ADDENDUM NUMBER ONE (001)

Date: March 22, 2019

Project: City of Portales
Portales Fire Substation Rebid
Chief Procurement Officer
100 West 1st Street
Portales, NM 88130
WHPacific Project Number: P0014007W
City of Portales Project Number: ITB: #2019-03-10

SKS-01
of

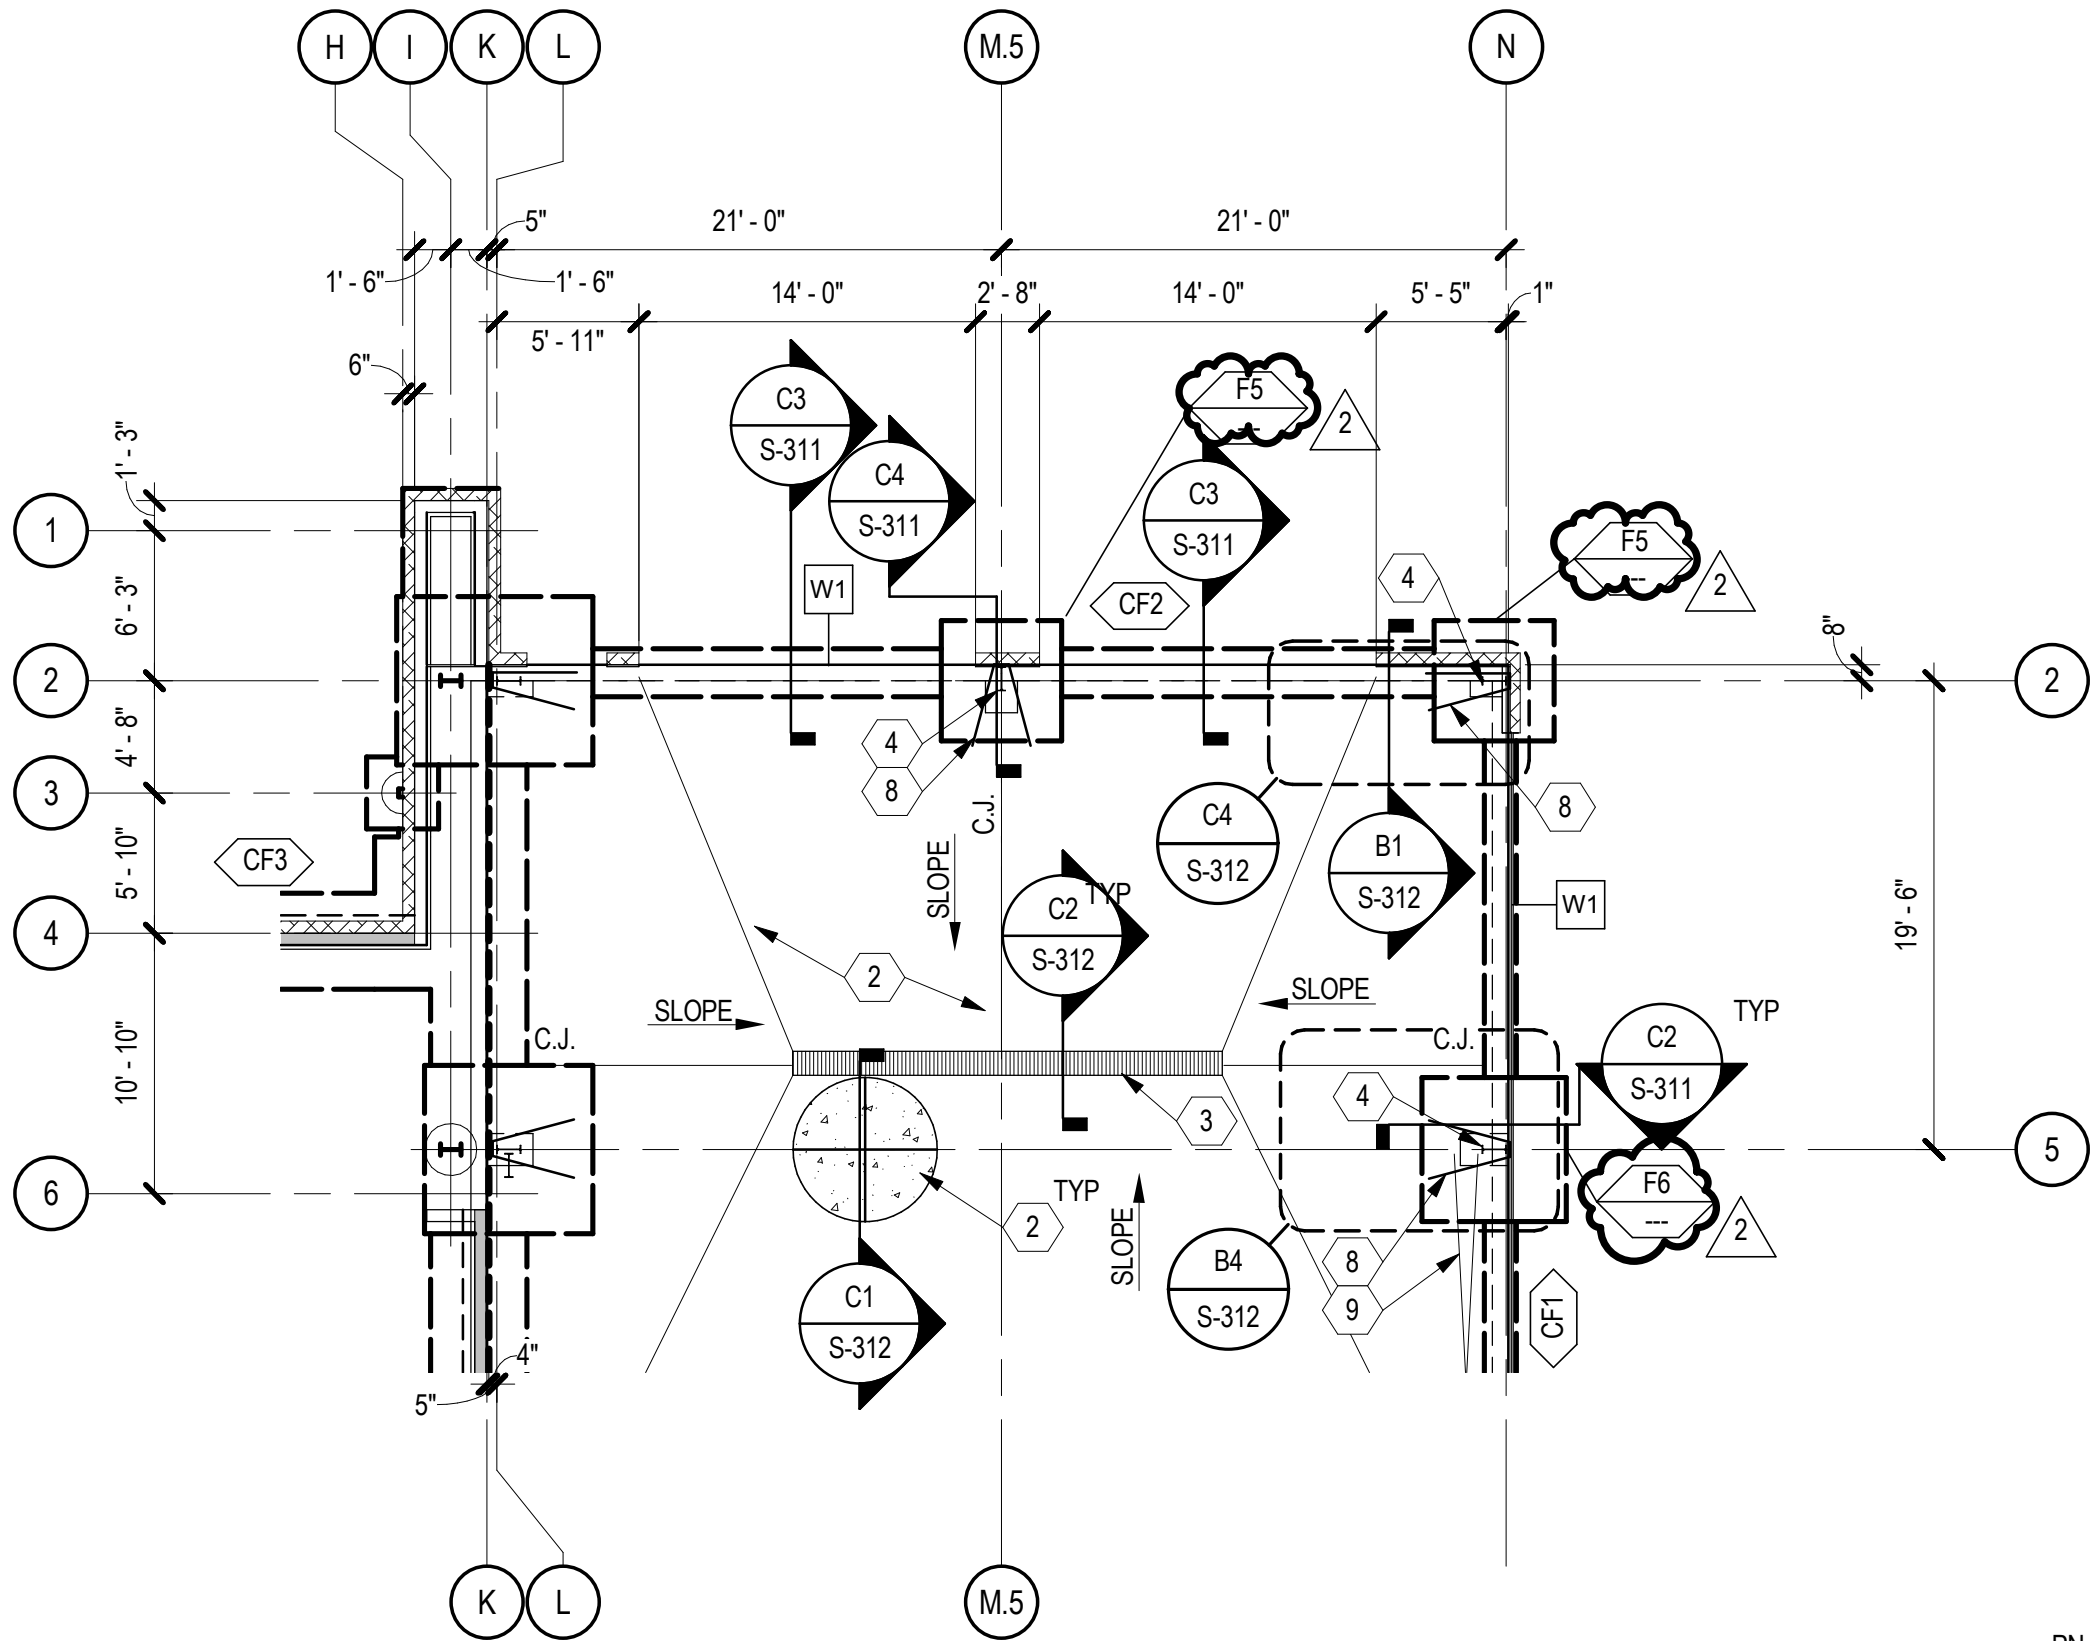
1. A1/S-101: **Delete** Base plate marks for Pre-Engineered building columns.
See sketch SKS-01 and SKS-02
2. A1/S-101: **Add** Base plate mark for HSS6x6x5/8 column at
Grid 7 and Grid K. See sketch SKS-02

SKS-03
of

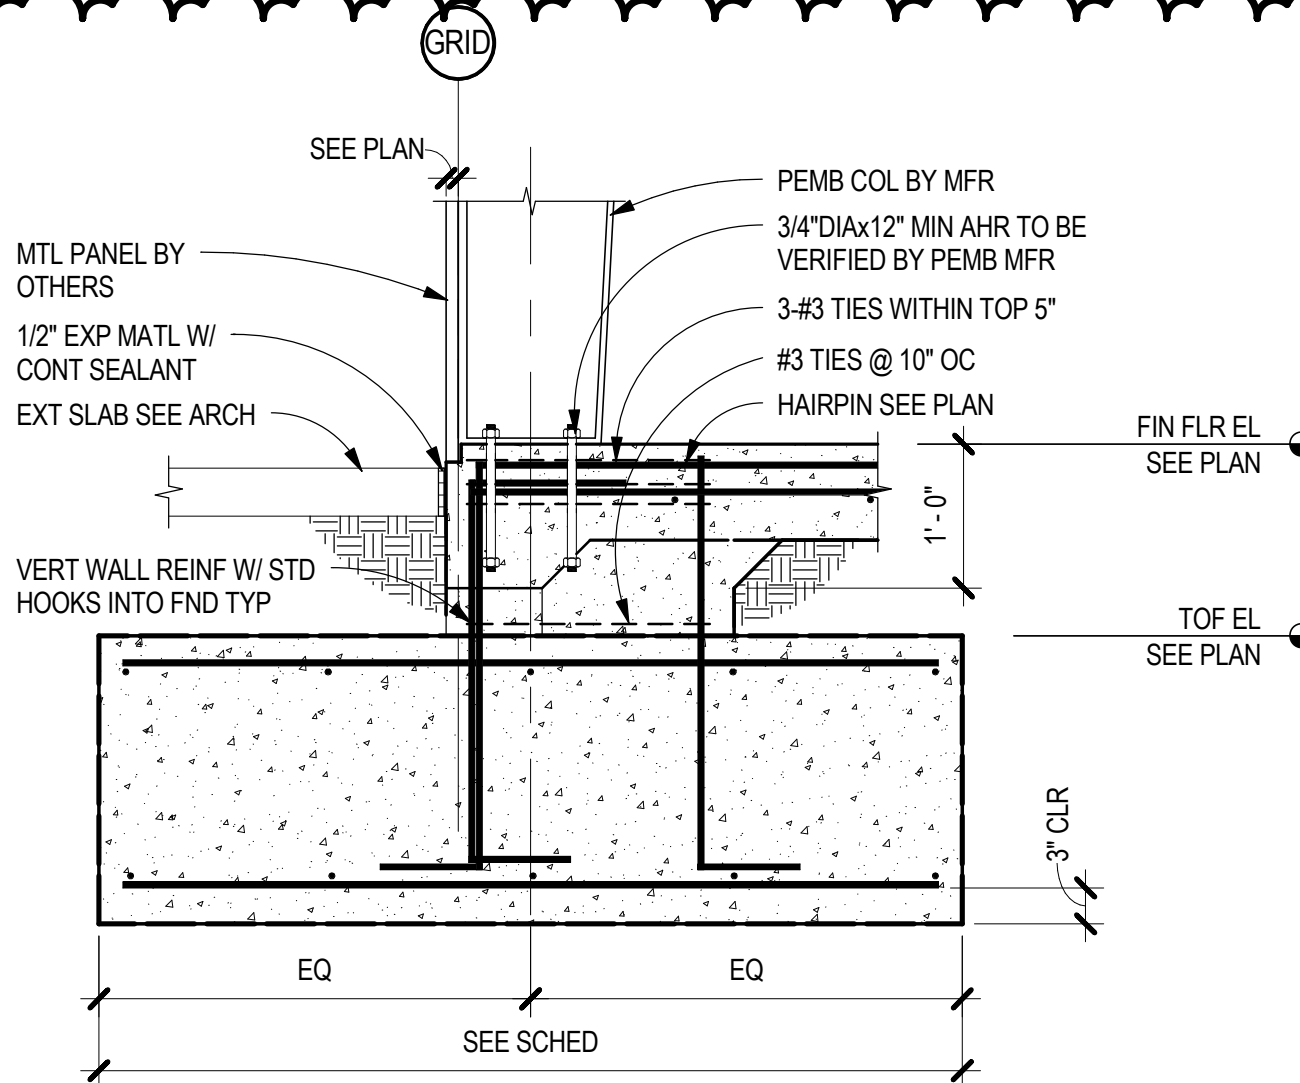
5. C2/S-311: **Add** Reinforcing 3-#3 Ties within top 5”, See sketch SKS-03
 6. C2/S-311: **Add** Reinforcing #3 Ties at 10” on center, See sketch SKS-03

SKS-04

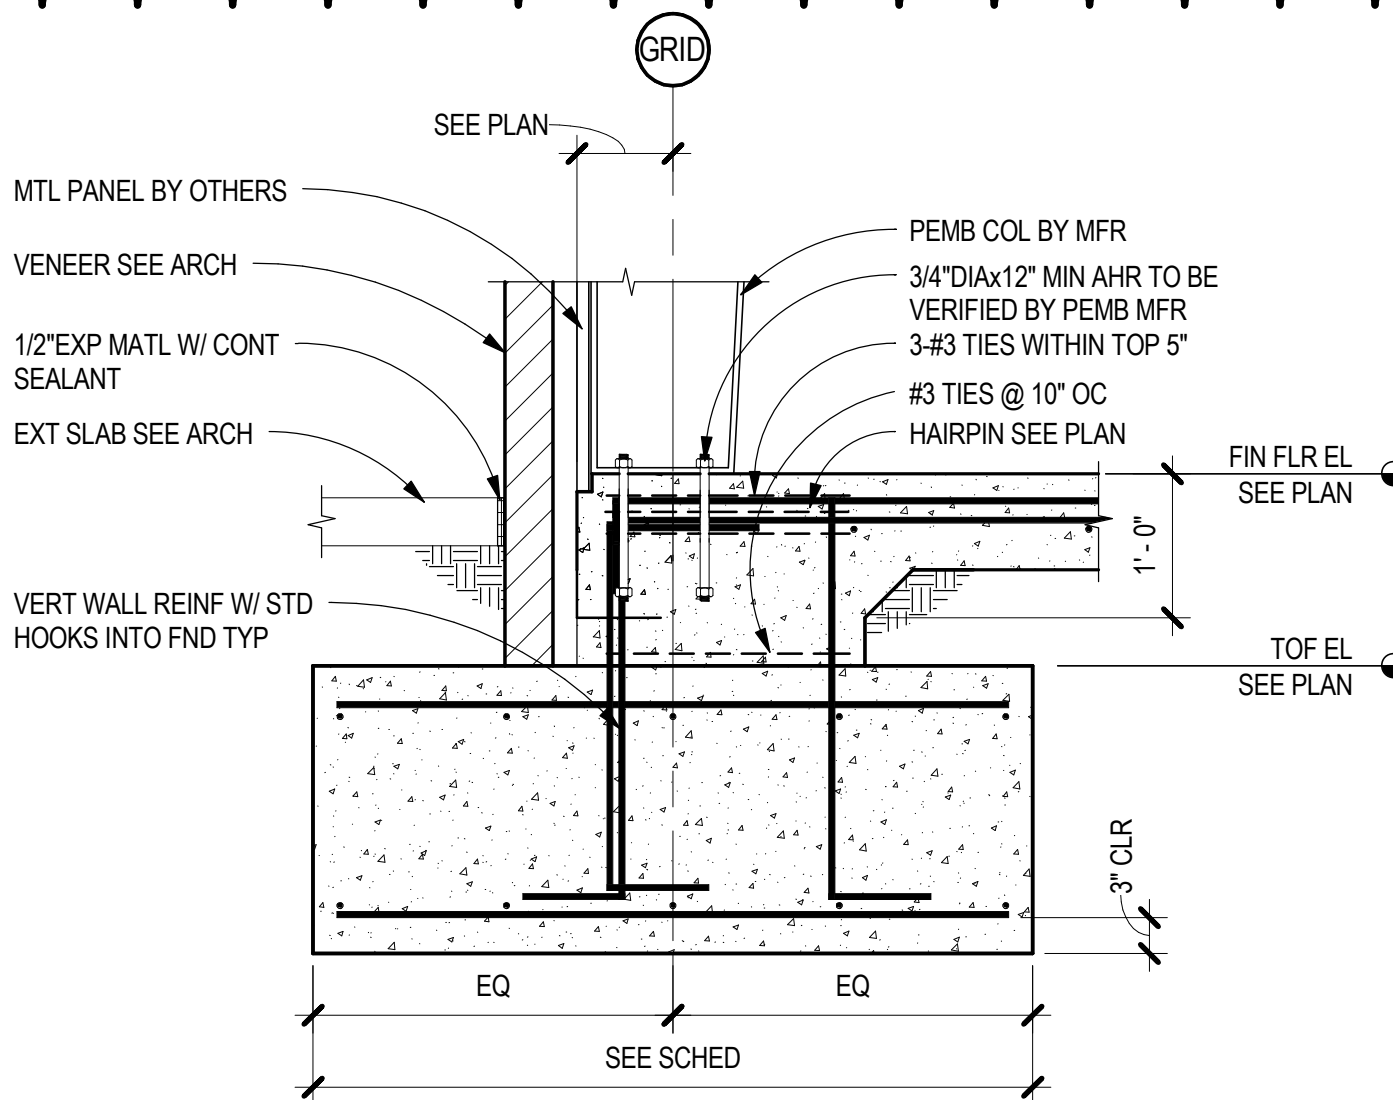
3. C4/S-311: **Add** Reinforcing 3-#3 Ties within top 5”, See sketch SKS-04
 4. C4/S-311: **Add** Reinforcing #3 Ties at 10” on center, See sketch SKS-04

SKS-06
of

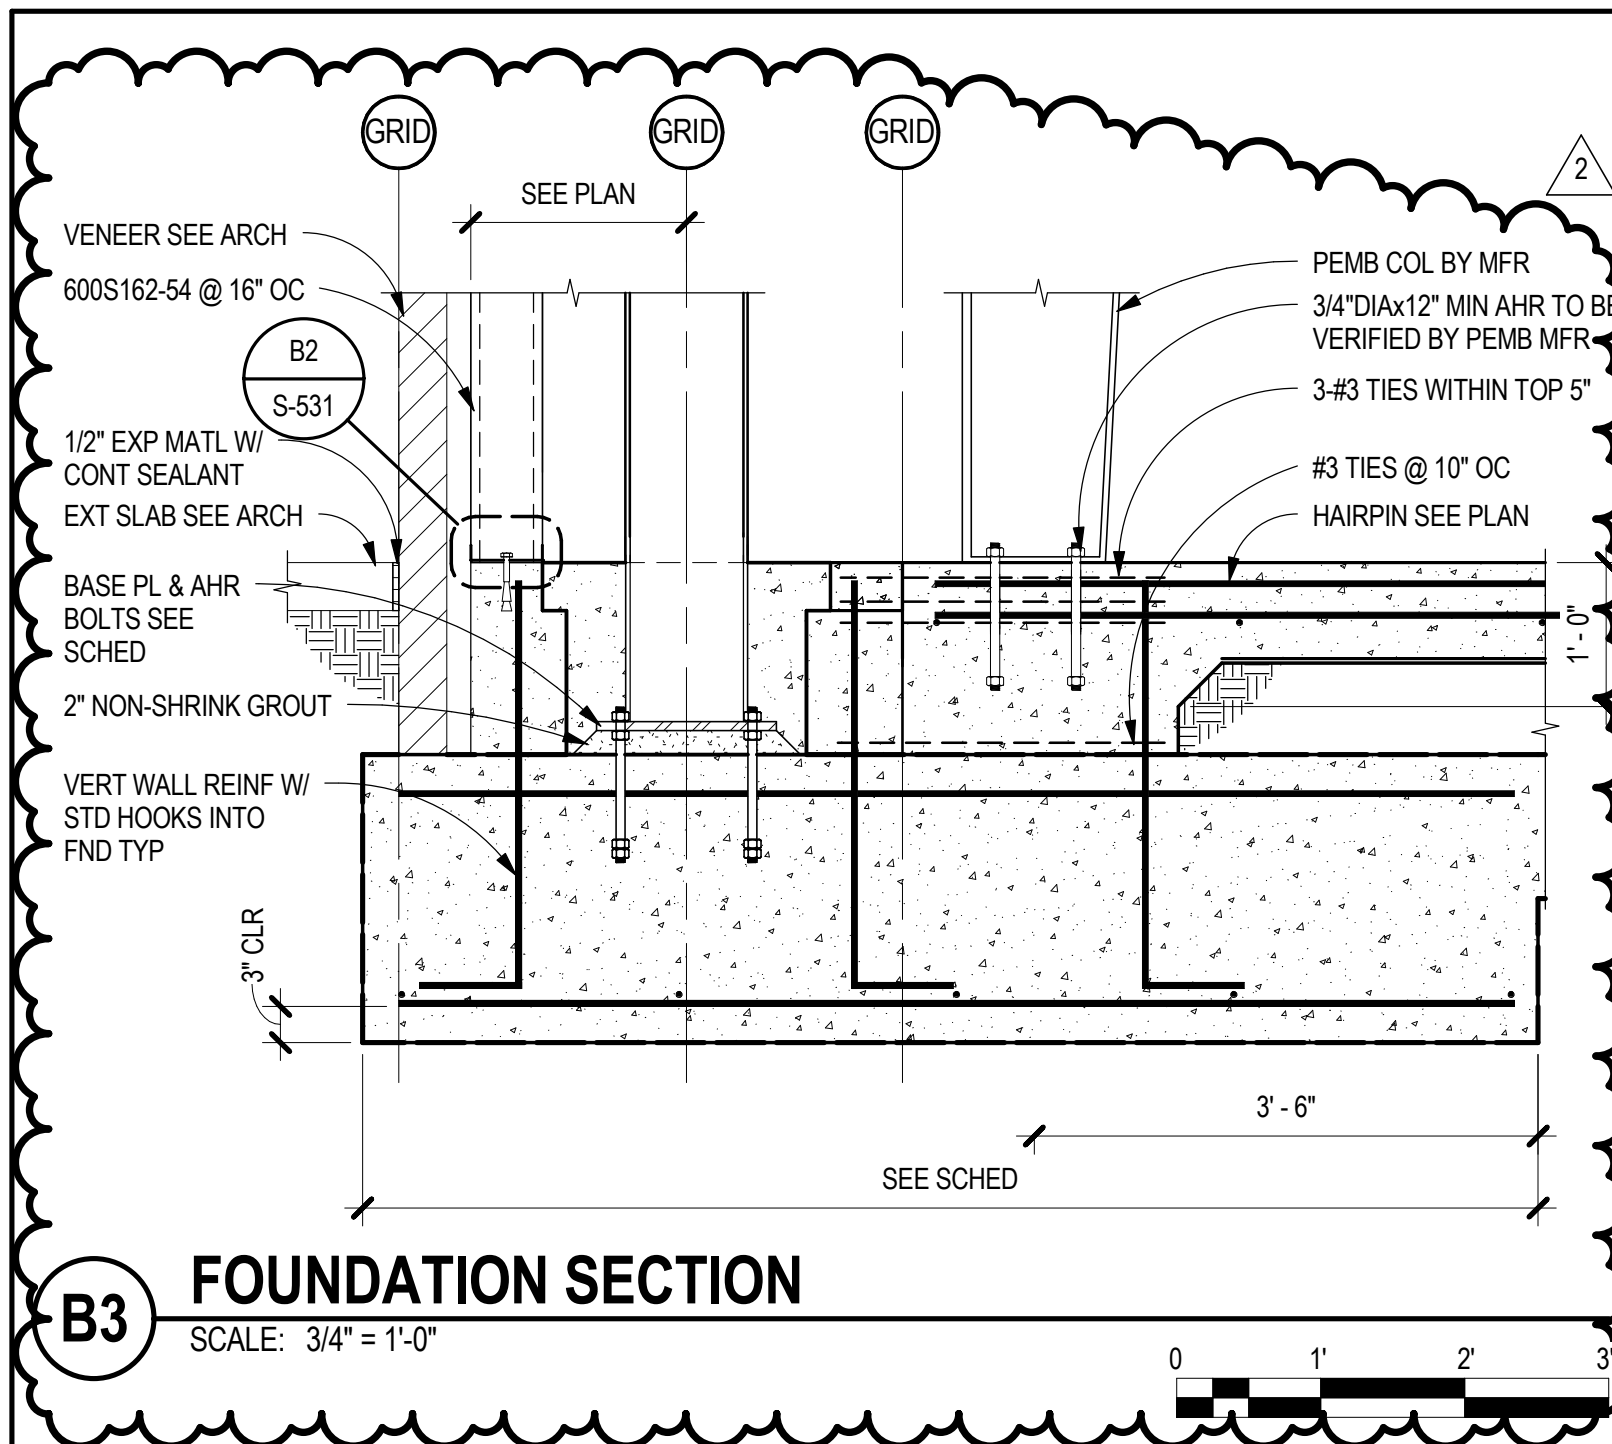
- g. **Revision:** Sheet S-312 FOUNDATION SECTIONS AND DETAILS
 7. B3/S-311: **Add** Reinforcing 3-#3 Ties within top 5”, See sketch SKS-06
 8. B3/S-311: **Add** Reinforcing #3 Ties at 10” on center, See sketch SKS-06

9. B3/S-311: **Add** Reinforcing vertical reinforcement with standard hook.
See sketch SKS-06
- h. **Revision:** Sheet S-322 ROOF FRAMING SECTIONS AND DETAILS
